# CITY OF ALBUQUERQUE

**RE: Presbyterian Rev. Hugh Cooper**  
**Grading Plan (Stamp Date 12/7/2015)**  
**Hydrology File: B17D003**

Based upon the information provided in your submittal received 12-07-2015, the above-referenced is approved for Site Plan for Building Permit and DRB action.

C101

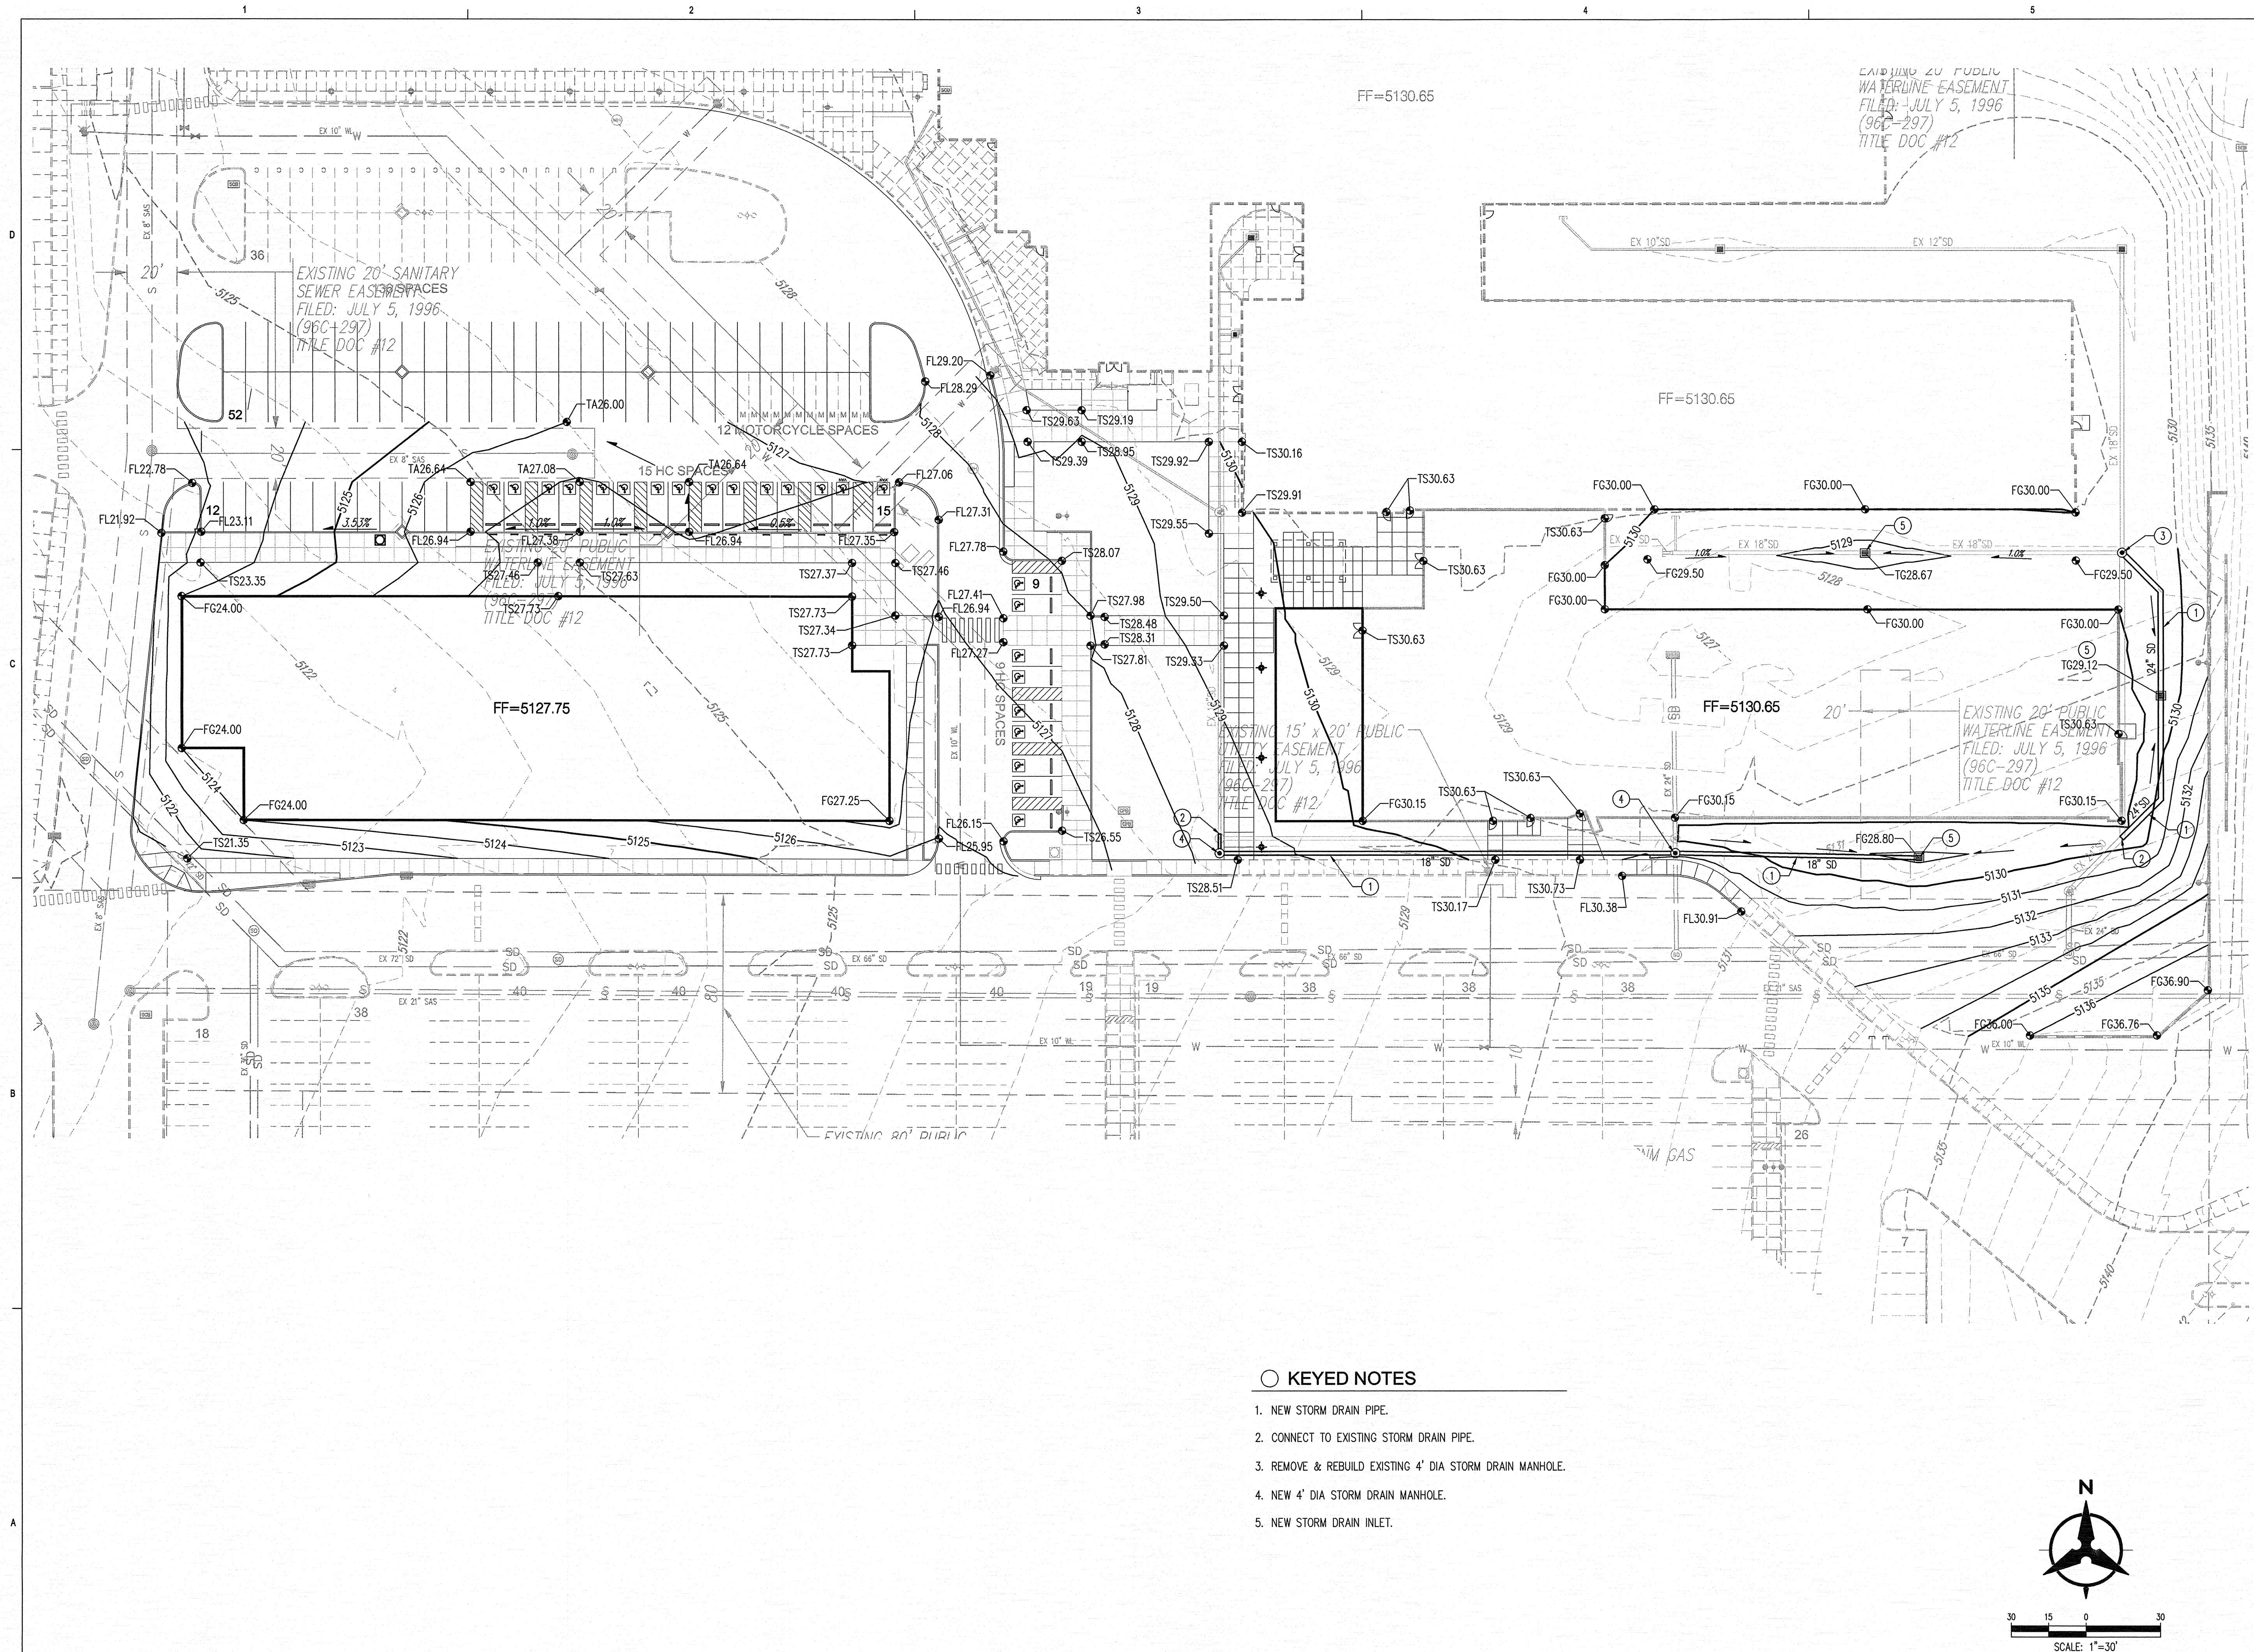
As previously discussed, we will expect to coordinate a storm water treatment feature for the parking lot outlet to maximize the compliance with the First Flush ordinance prior to Building Permit approval.
